ADDENDUM NO. 1

TO: All Holders of Plans and Contract Documents for City of Monett,
OOOS(628) Chapell Dr over BNSF Railroad,
Bridge # 2870013

ISSUED: 07/02/2026

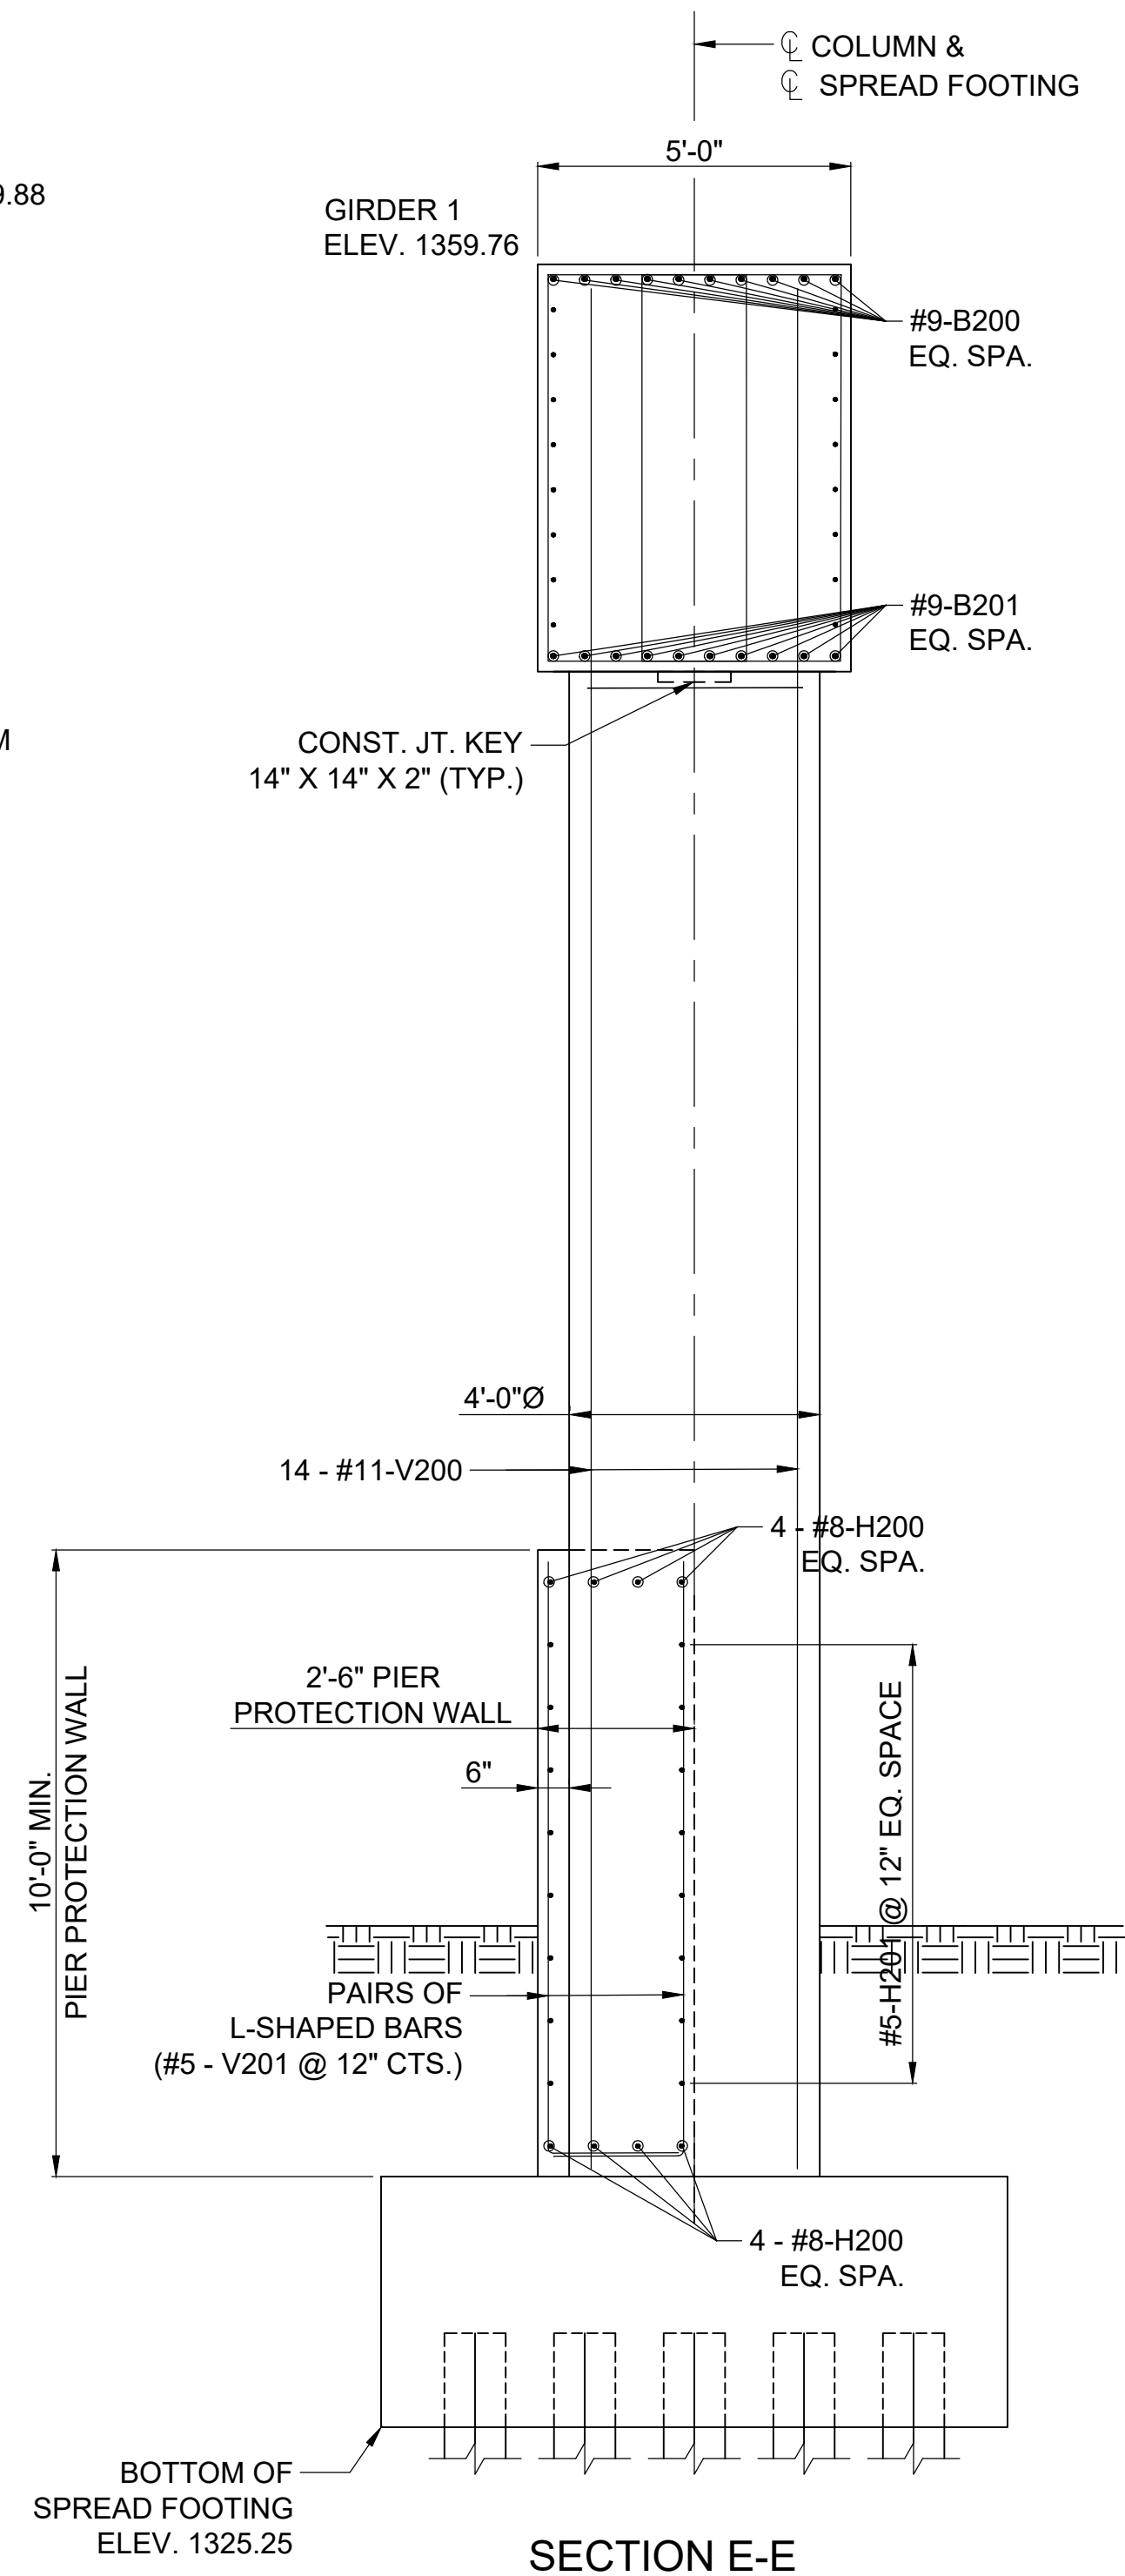
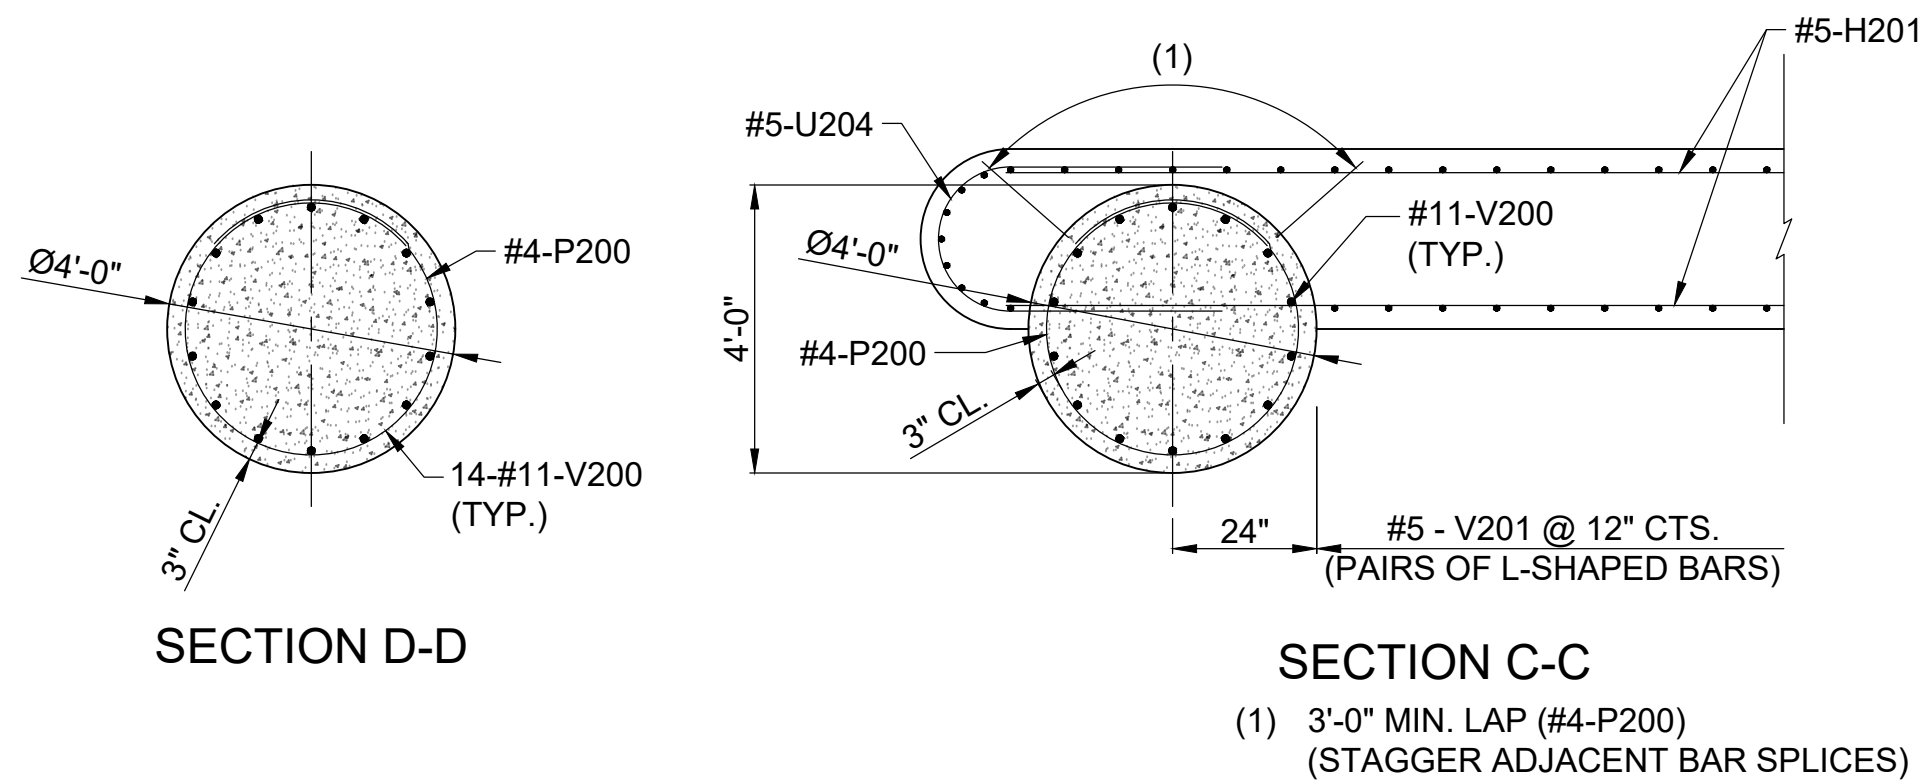
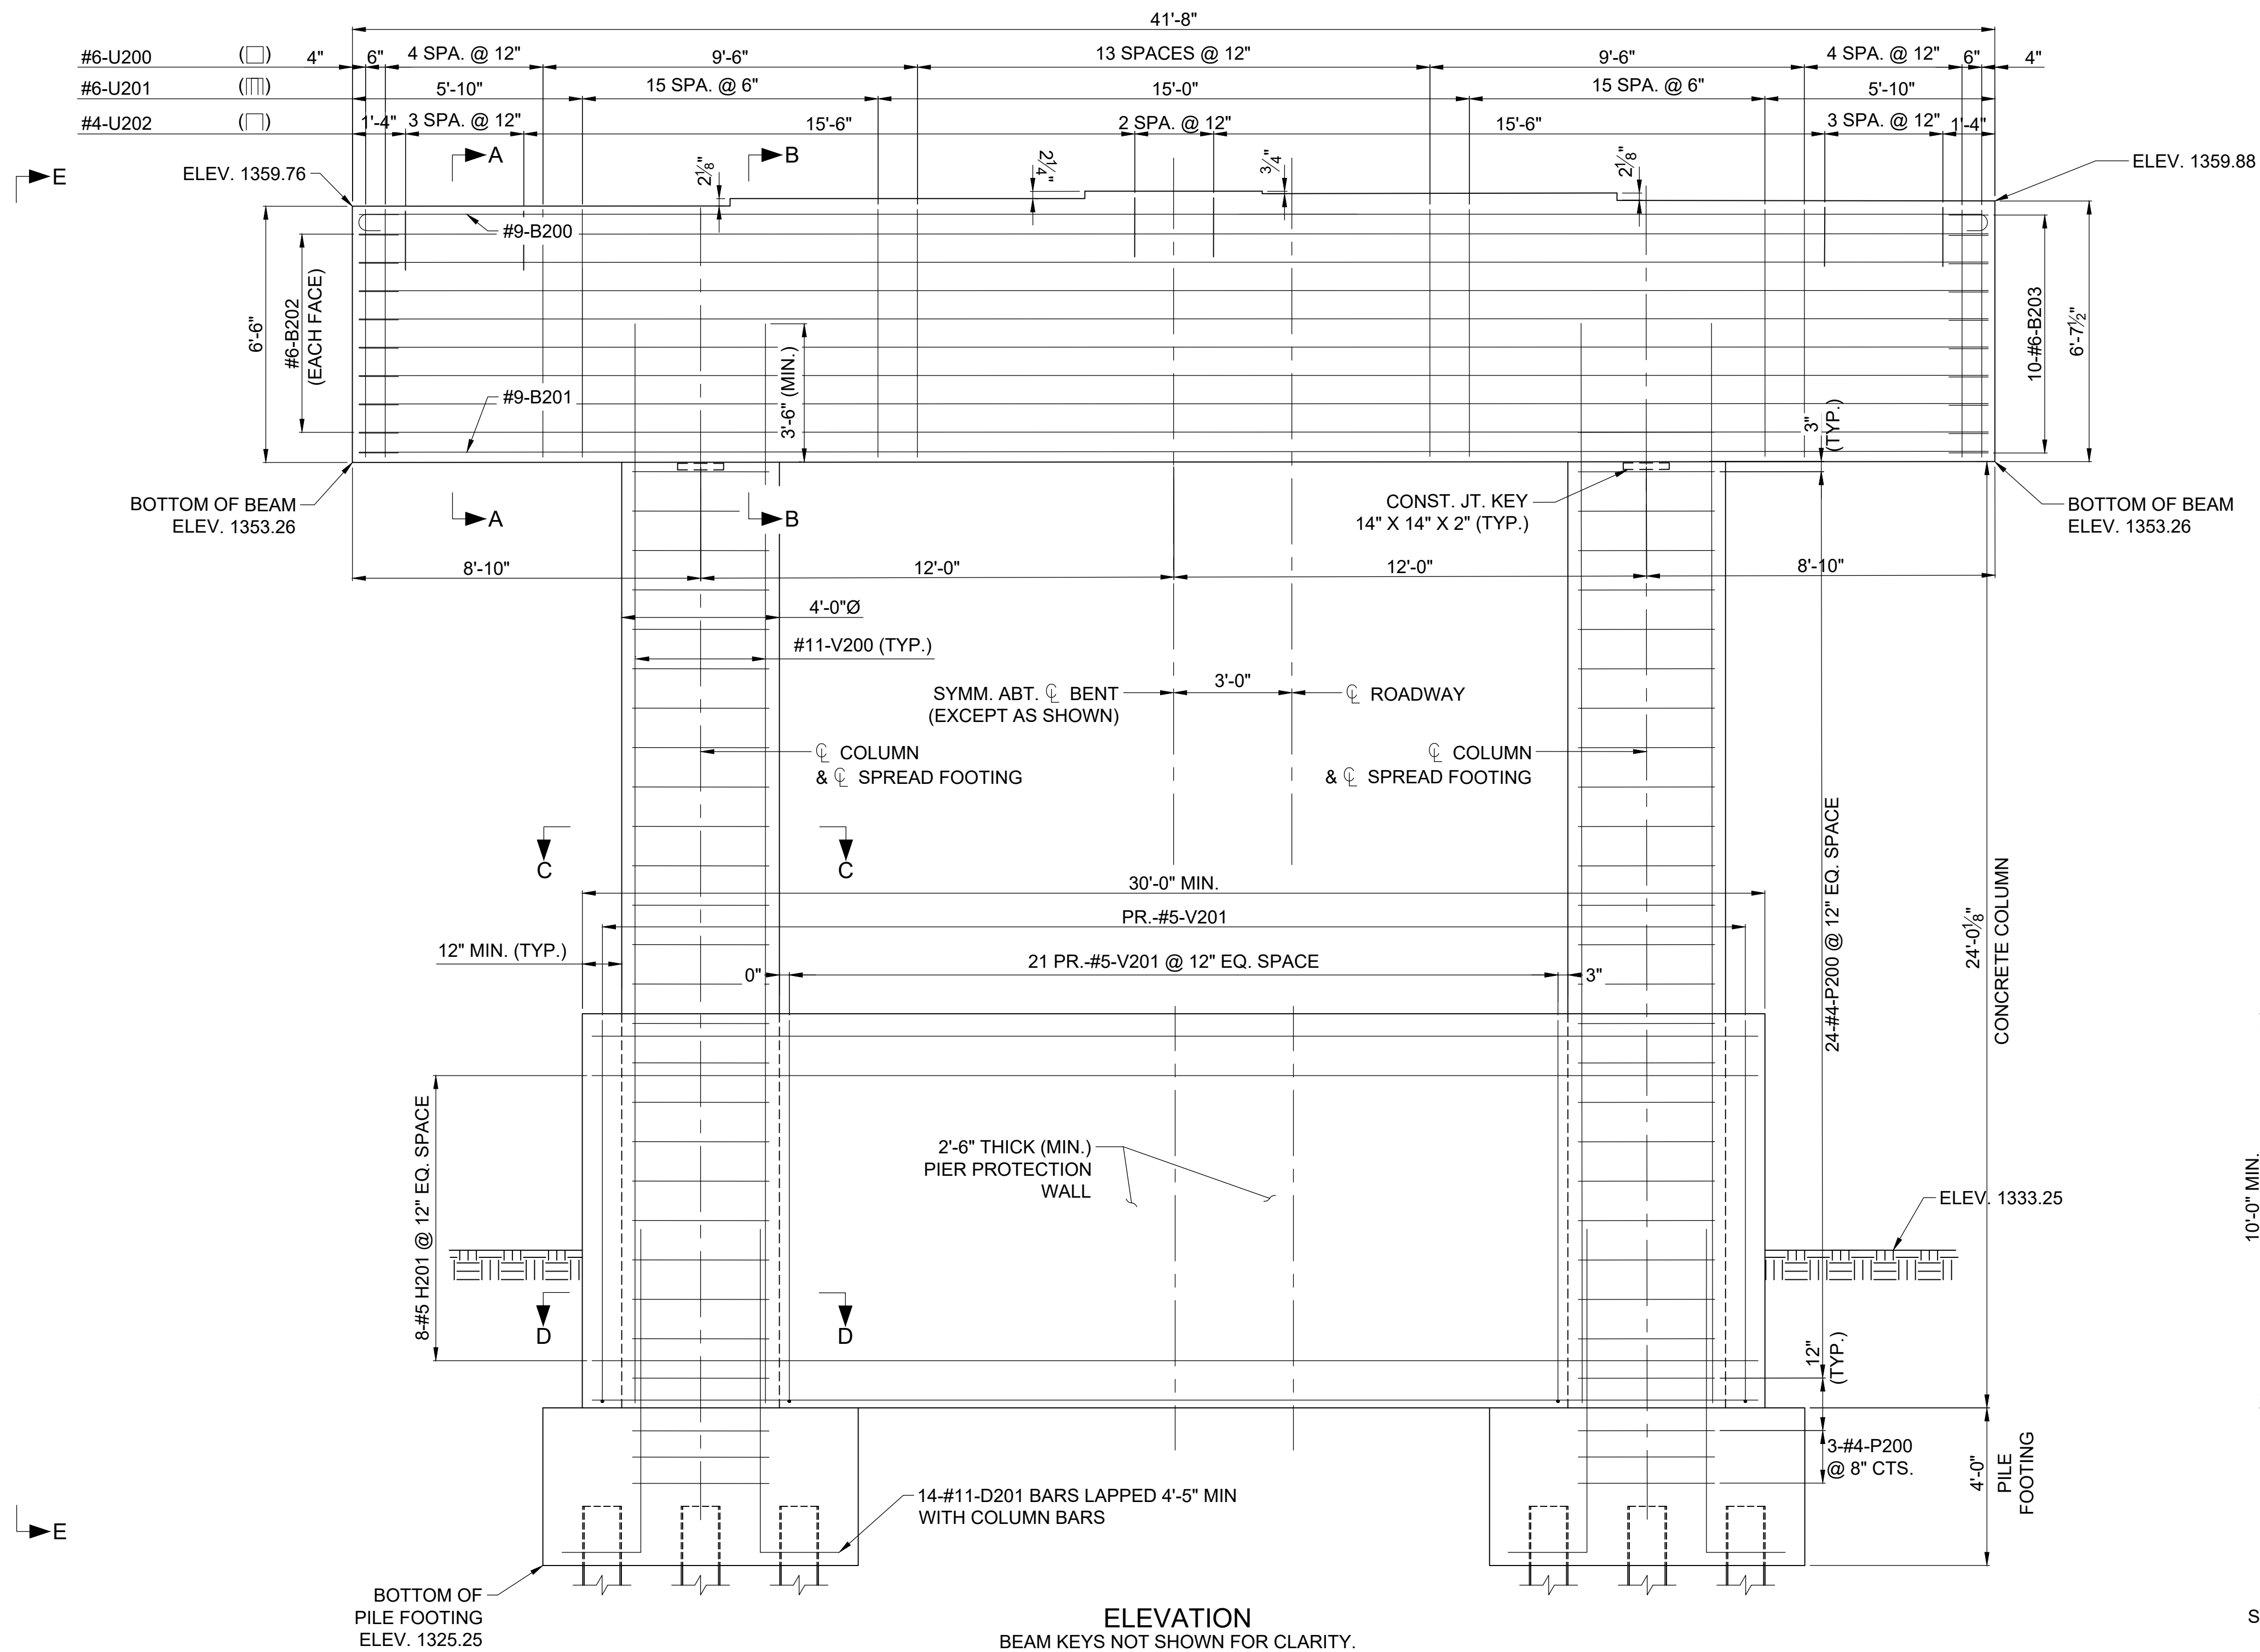
- Sheet 32 – Intermediate Bent 2A
 - Addition to Substructure Quantity Table for Bent No. 2
 - Addition of Item “Pre-bore For Piling” for clarity relating to Summary of Quantities and Itemized proposal

TOP FLANGE BLOCKOUT ⚠

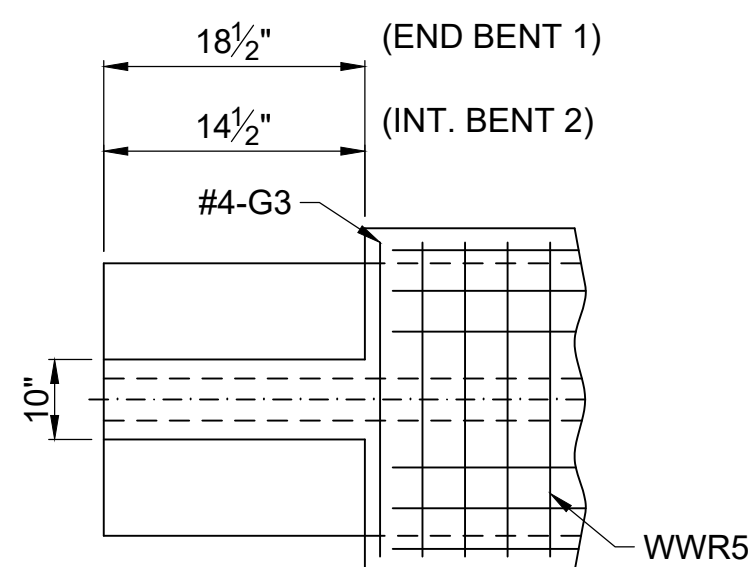
- Sheet 41 – Details of NU Girders Span 1-2
 - Revision to Top Flange Blockout Details
 - Revised “Left Exterior Girder at Intermediate Bent”
 - Revised “Left Exterior Girder at Intermediate Bent” to “Left Exterior Girder at Intermediate Bent 2”

- Revised exterior blockout dimension (top dimension) from 9” to 7½”
 - Revised interior blockout dimension (bottom dimension) from 18½” to 14½”
 - Revised “Interior Girder at All Bents & Exterior Girder at End Bents”

- Revised “Interior Girder at All Bents & Exterior Girder at End Bents” to “Interior Girder at End Bent 1 and Intermediate Bent 2 & Exterior Girder at End Bent 1”

- Revised “Int. Bent” dimension from 18½” to 14½”

TOP FLANGE BLOCKOUT ⚠

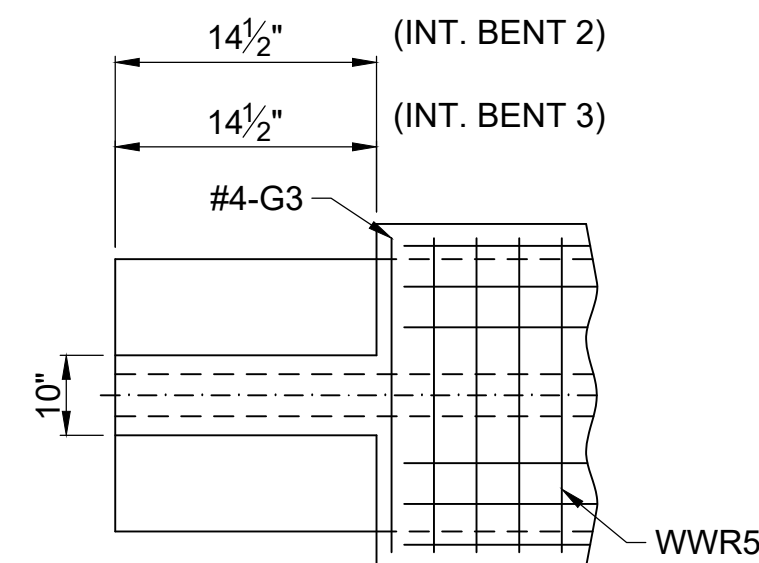
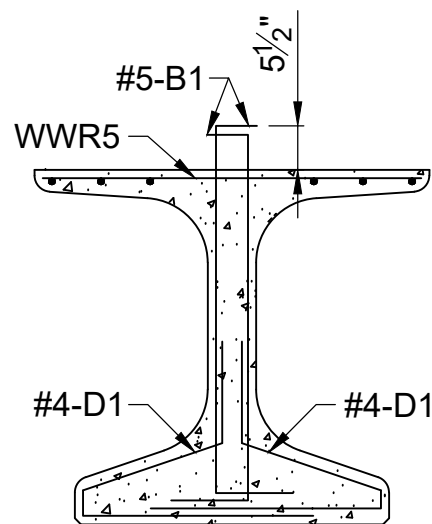
- Sheet 42 – Details of NU Girders Span 2-3
 - Revision to Top Flange Blockout Details
 - Revised “Left Exterior Girder at Intermediate Bent”
 - Revised “Left Exterior Girder at Intermediate Bent” to “Left Exterior Girder at Intermediate Bent 2 and 3”

- Revised exterior blockout dimension (top dimension) from 9” to 7½”
 - Revised interior blockout dimension (bottom dimension) from 18½” to 14½”
 - Revised “Interior Girder at All Bents & Exterior Girder at End Bents”

- Revised “Interior Girder at All Bents & Exterior Girder at End Bents” to “Interior Girder at Intermediate Bent 2 and 3”
 - Revised “End Bent” to “Int. Bent 2”

- Revised “Int. Bent 2” dimension from 18½” to 14½”
 - Revised “Int. Bent” to “Int. Bent 3”
 - Revised “Int. Bent 3” dimension from 18½” to 14½”
- Sheet 43 – Details of NU Girders Span 3-4
